Replacing the electronic vitiator and control panel on the RHSC90

9 March 2017

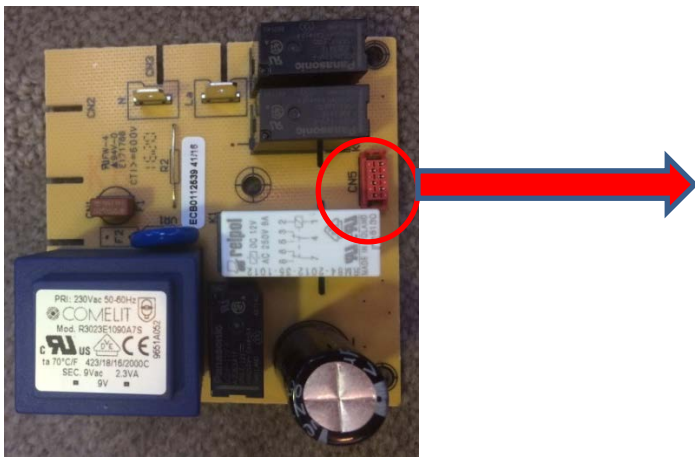
Due to a change in design to how the wiring connecting the electronic vitiator and control panel connects, when installing the new parts, the connection direction changes.

The plug connects at the red CN5 part of the electronic vitiator with the wire connected to the control panel running away from the electronic vitiator.

Reverse the plug direction. So, the plug connects at the red CN5 part of the electronic vitiator with the wire connected to the control panel running over from the electronic vitiator.
